**DOCKET ITEM #6**  
**Development Site Plan #2014-0044**  
**500 Pendleton Street – Adams Residence**

Application	General Data	
<b>Project Name:</b> Adams Residence	PC Hearing:	May 5, 2015
	If approved, DSP Expiration:	May 5, 2018
	Lot Size:	3,024 square feet
<b>Location:</b> 500 Pendleton Street	Zone:	RM, Townhouse Zone
	Proposed Use:	Residential
	Dwelling Units:	One
	Gross Floor Area:	3,896 square feet (w/expansion)
<b>Applicant:</b> General & Mrs. Harold Adams	Small Area Plan:	Old Town North
	Historic District:	N/A

To construct a one-story addition to an existing townhouse

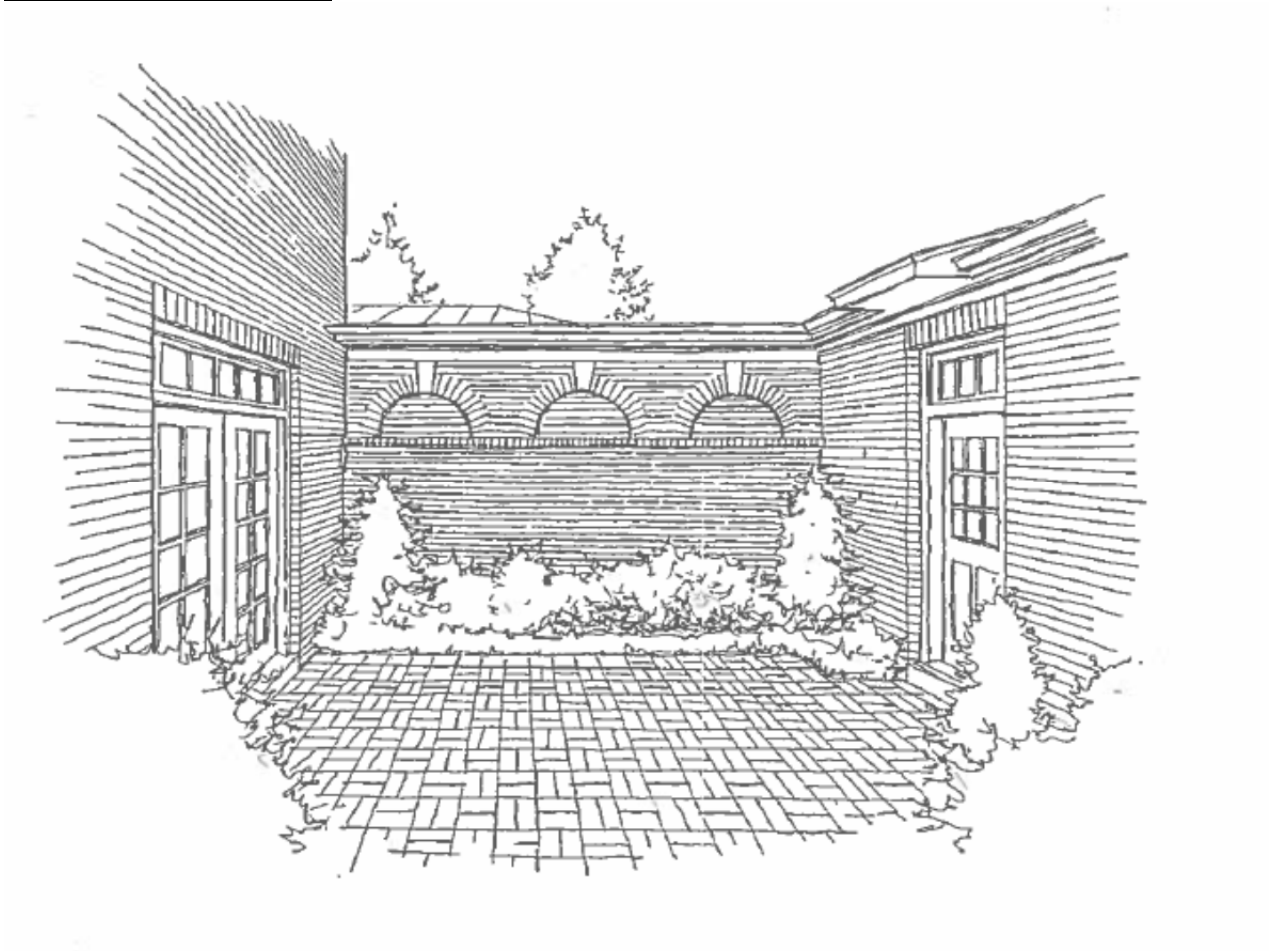
- R1. On the cover sheet, Table 1: Revise the two asterisked notes by replacing DUP with DSP;
- R2. On the cover sheet, Zoning Information: Shift the 35% min reference from Density to Open Space.
- R3. On the cover sheet, Applications: Remove the reference for a need for a rear yard modification. It was determined during the review that a modification request was not necessary as the infill addition will conform to the required setback.

- 1. Staff recommends not building over the existing privately owned and maintained storm sewer system. (I-ROW)
